ADDENDUM NO. 3
April 30, 2026

The following changes, additions, and/or deletions and clarification are hereby made part of the CONTRACT DOCUMENTS FOR BEAVER CREEK INFILTRATION GALLERY for which are to be received by **noon Tuesday May 5, 2026**. This ADDENDUM NO. 3 takes precedence over the original Contract Documents as noted. Except as presented herein, all other conditions of the contract remain as presented in the original Contract Documents.

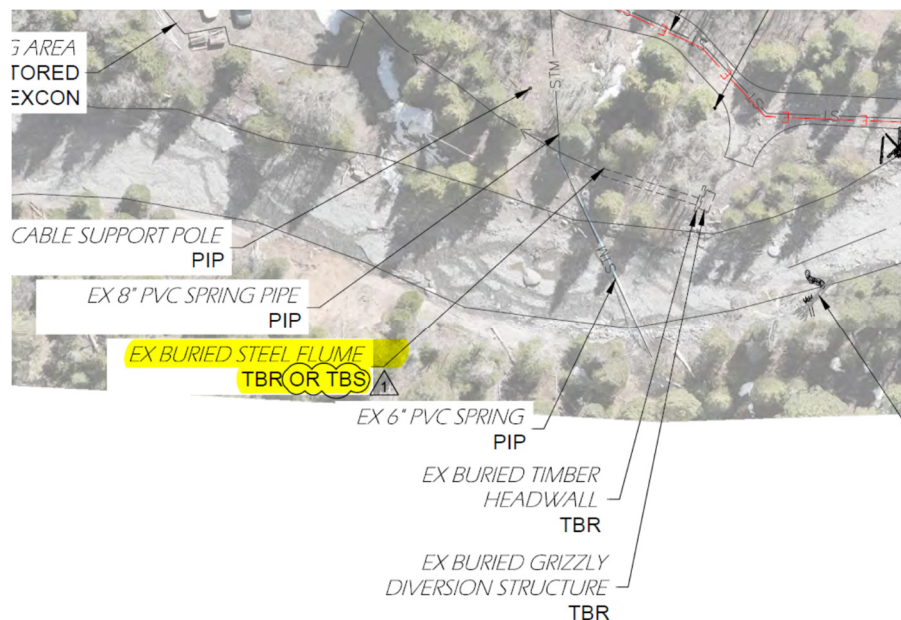
CLARIFY: [SECTION 02 4113] Sheet C-1, Clarify that the removal highlighted in the snapshot below includes removal of about 100 LF of debris buried steel flume / trough.
